TITLE: Sheet_1		REV: 1.0
	Company: Your Company	Sheet: 1/1
	Date: 2021-01-01 Drawn By: Stefan

TITLE: Sheet_3		REV: 1.0
		Sheet: 1/1
	Company: Your Company	Date: 2021-01-02 Drawn By: Stefan

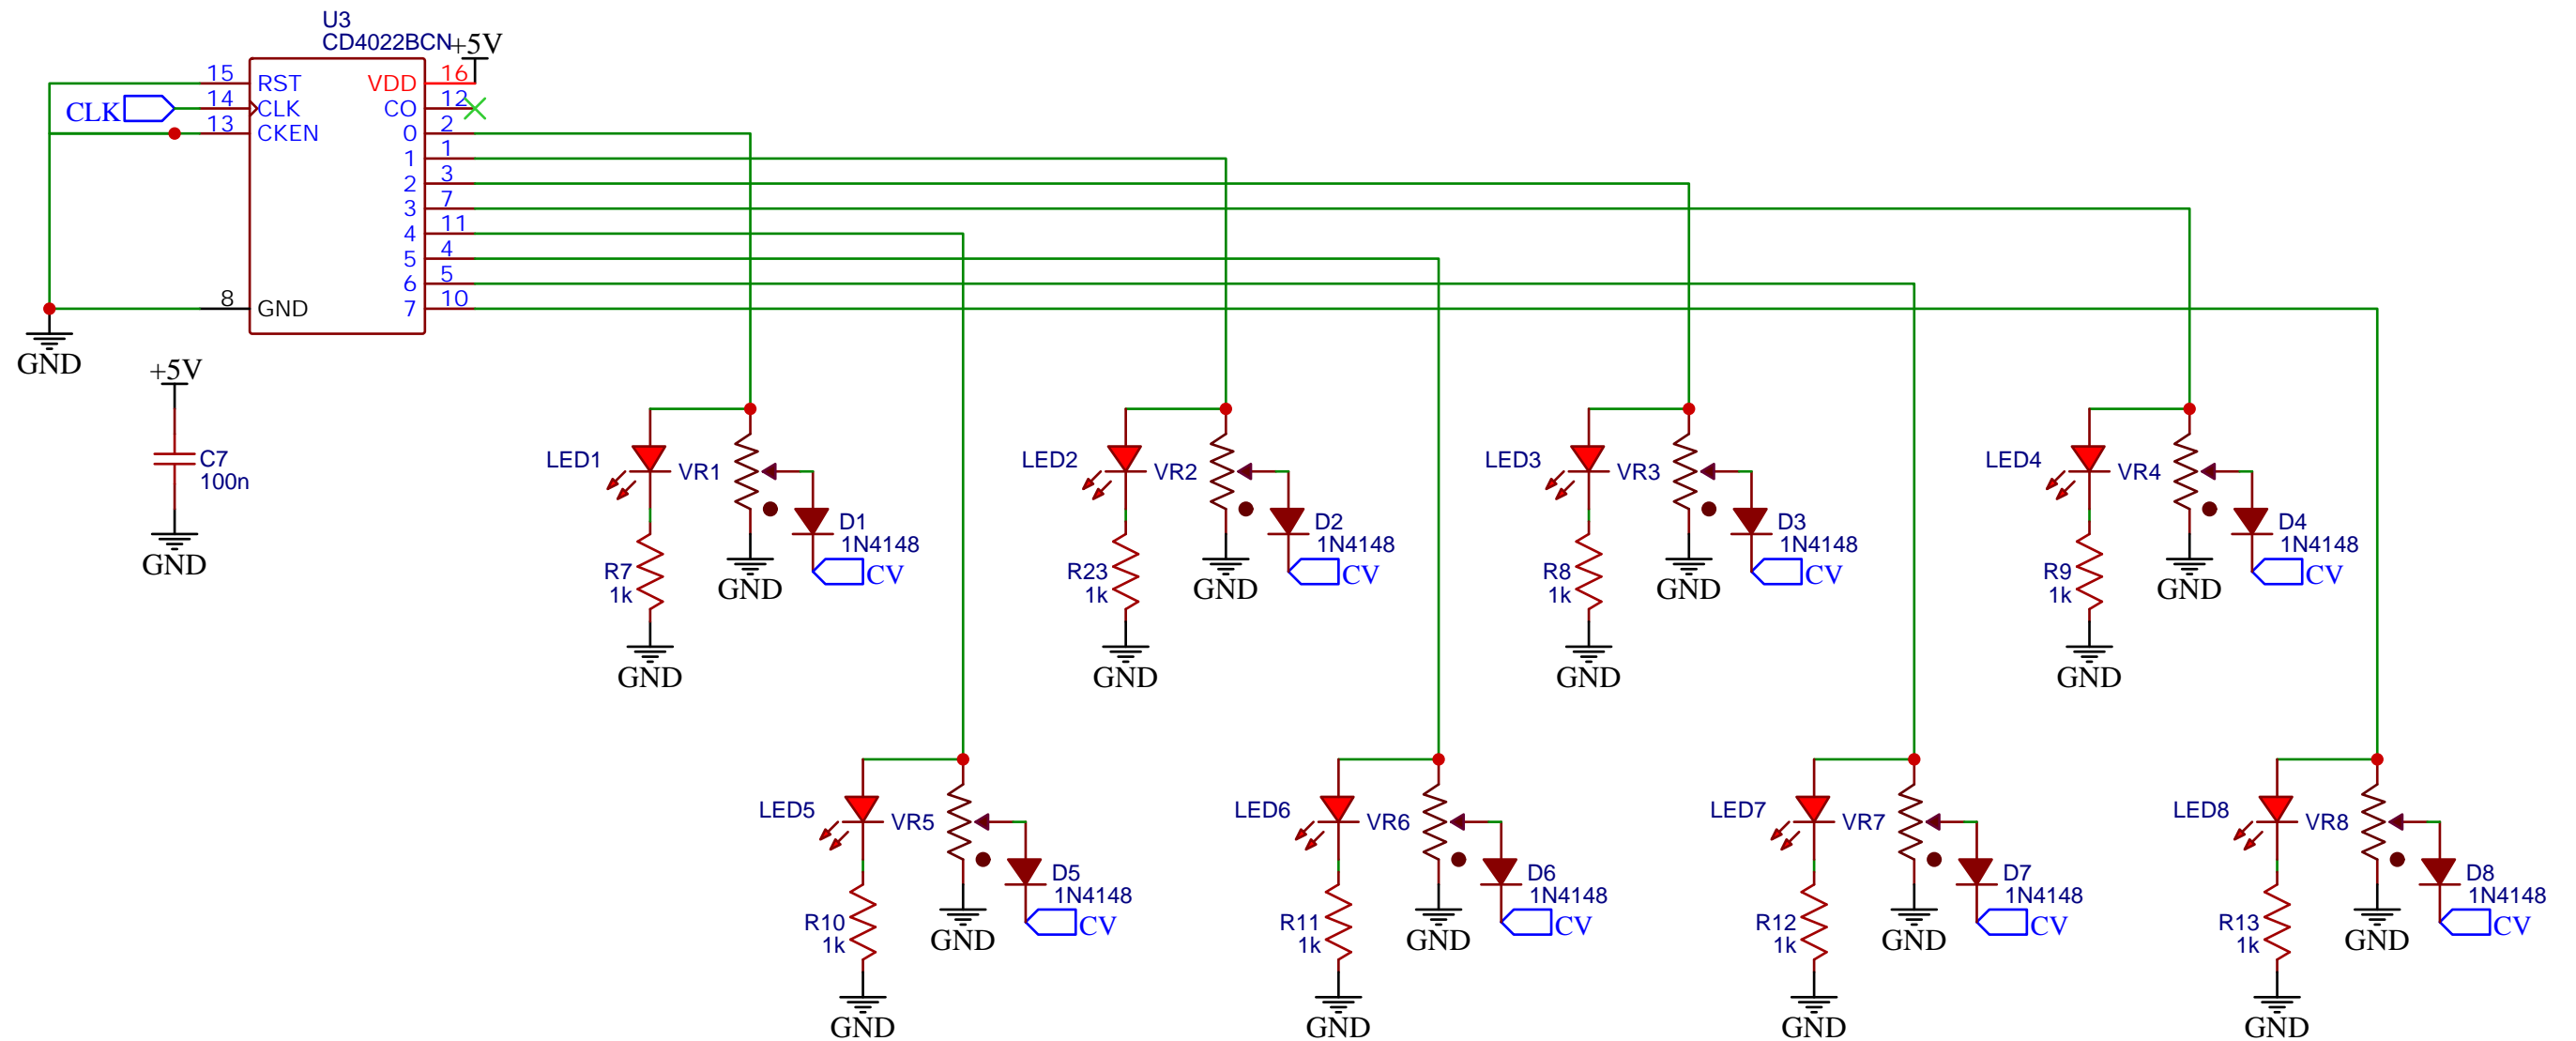
Original was 100u
Is that right?
Resistors x10 to compensate
